Models	1990-93 300ZX
Section	Service Campaign
Classification	P4120
Bulletin No.	NTB94-096
Date	October 20, 1994

VOLUNTARY SERVICE CAMPAIGN ON 1990-93 300ZX IGNITION POWER TRANSISTOR UNIT

APPLIED MODEL All 1990-1993 300ZX (Z32)

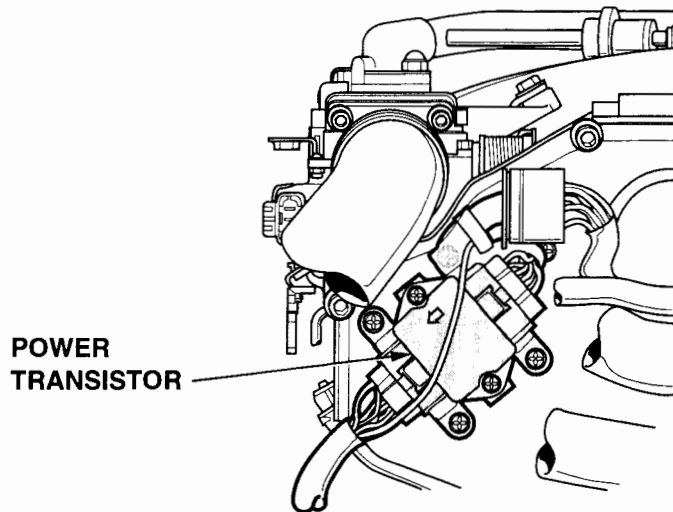
An electrical problem in the power transistor unit may cause poor driveability and/or rough idle. A counter measure power transistor unit has been developed to resolve this incident.

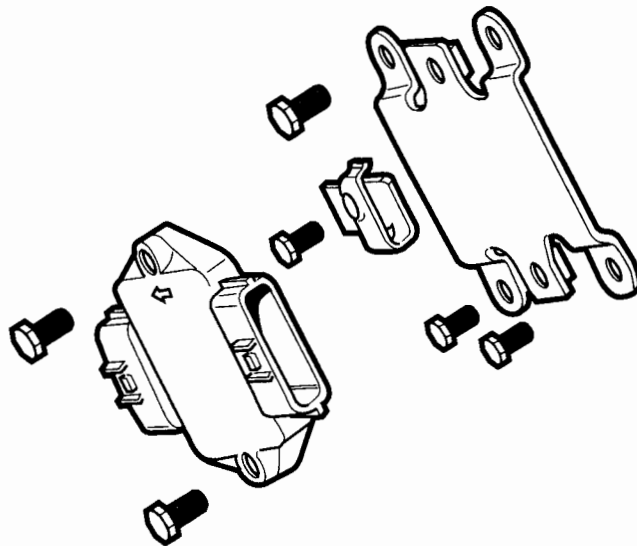
1. Open the Hood.
2. Remove the air ducting to the throttle body.
3. Disconnect the power transistor harness connectors.
4. Remove the four bolts holding the power transistor to the timing belt cover.

5. Install the new power transistor bracket.
6. Install the new power transistor.

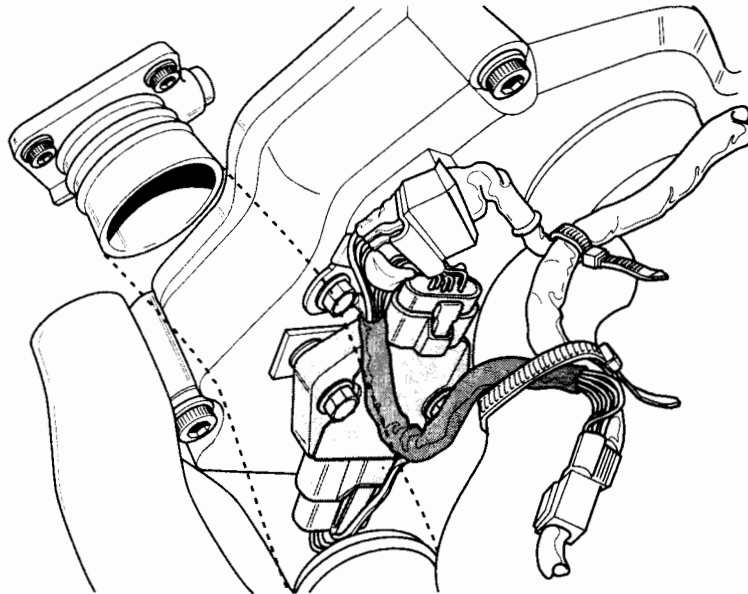
7. Connect the power transistor sub harness connectors to the existing engine harness connectors for the old power transistor.

8. Secure the harnesses into the clip on the timing belt cover. Tie wrap the other harness to the upper radiator hose as shown in the illustration above. Do Not over tighten the tie wrap on the radiator hose, as this will restrict coolant flow.

NOTE: Keep clearance at least 5 mm between the air duct and the clip/sub-harness. Keep clearance of at least 5 mm between connector and hood support rod.
